# SERVICE BULLETIN

## AA-SB-53-002

### Stabilator Hinge Brackets - replacement

Figure 2-1

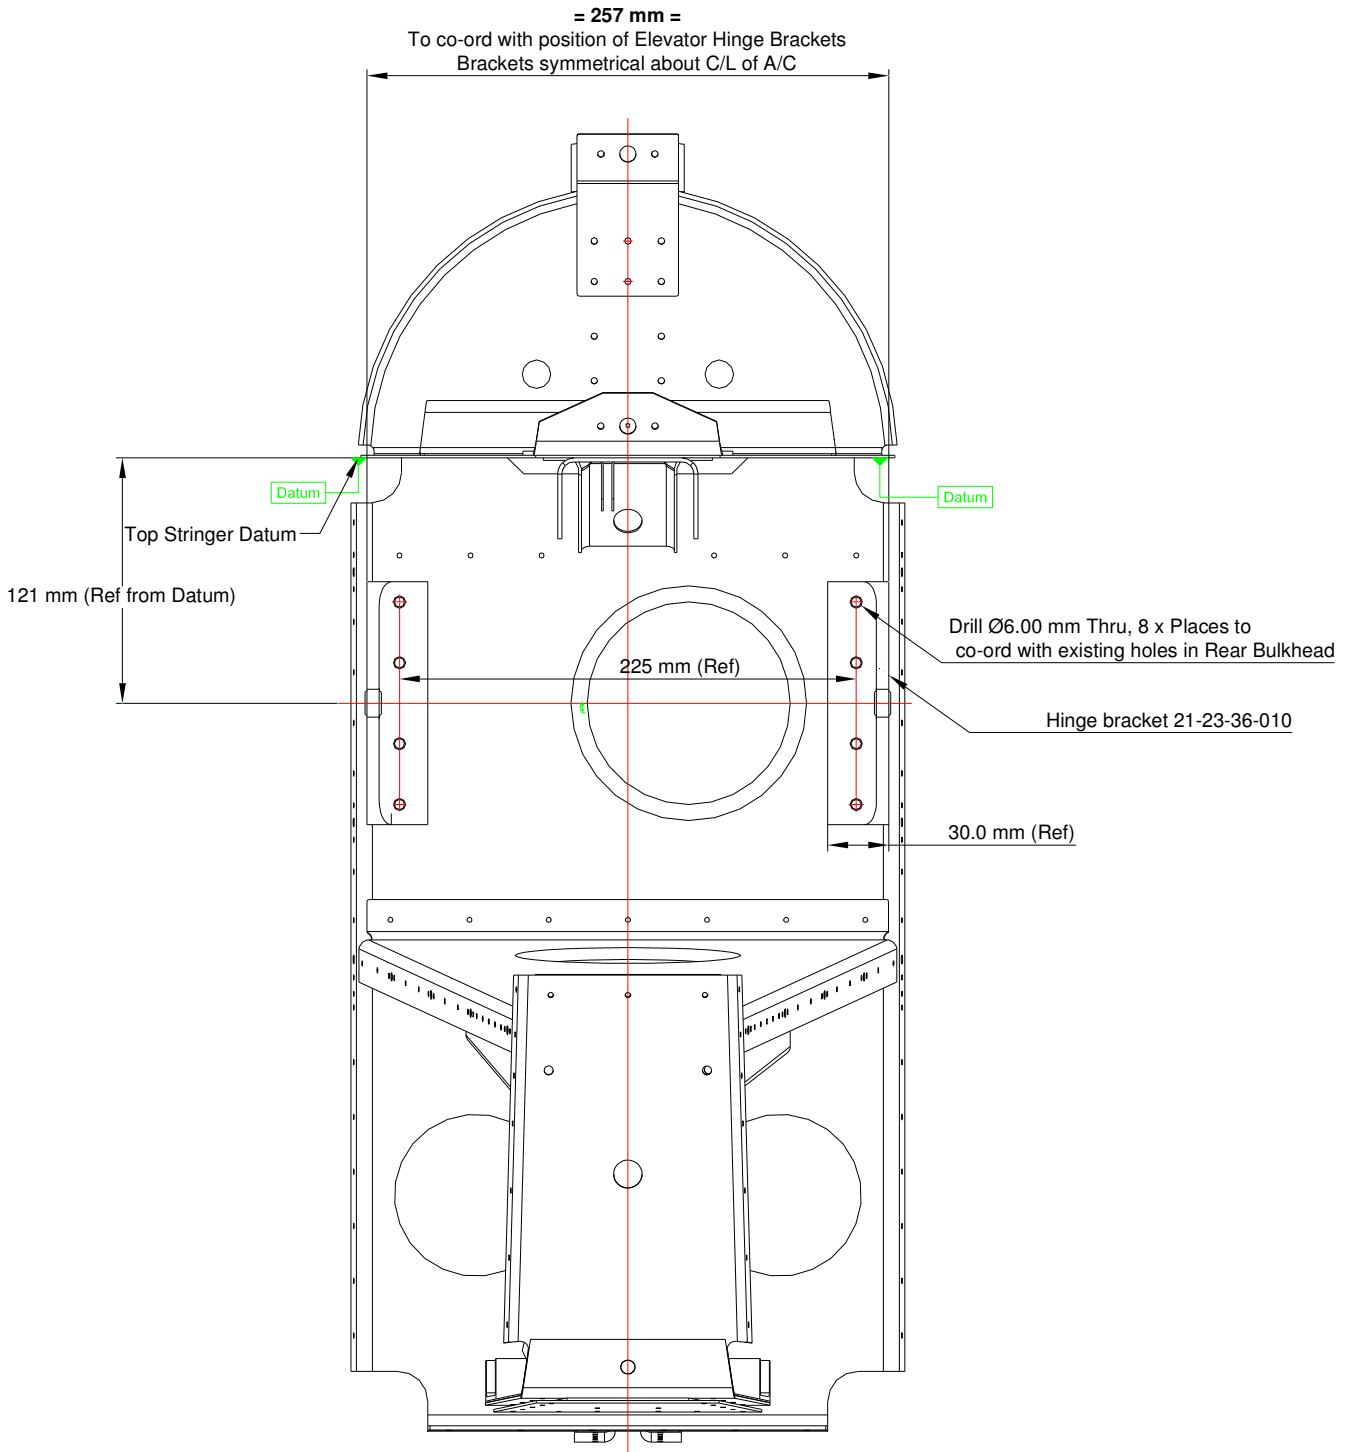
It has become evident that historical manufacturing tolerances have resulted in some lack of interchangeability of stabilator assemblies. In particular, new stabilators or stabilators embodying main spar components from current production may not be compatible with fuselage hinge bracket lateral spacing.

Existing p/n 21-23-36-000 hinge brackets are removed and replacement p/n 21-23-36-010 hinge brackets are installed.

- i) With reference to the R2000 series service manual, section 4.4, remove stabilator.
- ii) With reference to Figure 2-1 determine the distance between the outer faces of the existing 21-23-36-000 brackets. The correct design distance is the distance of 257 mm shown on figure 2-1.
- iii) If the distance determined is 257 mm then new stabilators or stabilators embodying main spar components from current production will be compatible and no further action is required.
- iv) If the distance determined is not 257 mm then existing brackets will need replacement if new stabilators or stabilators embodying main spar components from current production are to be installed.

- i) Obtain two brackets part number 21-23-36-010. These brackets differ from the standard brackets by having a wider attachment flange (30 mm rather 25 mm) and are supplied with attachment holes undrilled. Brackets will be supplied with an approved bearing installed.

- ii) The installed geometry to be achieved is shown in figure 2-1. This geometry is now jig controlled and the dimensions do not have a tolerance band. It is recommended that a locally made jig fixture be produced to ensure that the required geometry is achieved.

- iii) When the required geometry has been established transfer the attachment hole locations from the fuselage rear bulkhead to the p/n 21-23-36-010 brackets. Finish holes in the brackets by drilling 6 mm

- iv) Install brackets on the rear bulkhead using existing hardware. Install the attachment bolts with the nuts and washers inside the bulkhead and torque attachment bolts to 44 inch /lb.
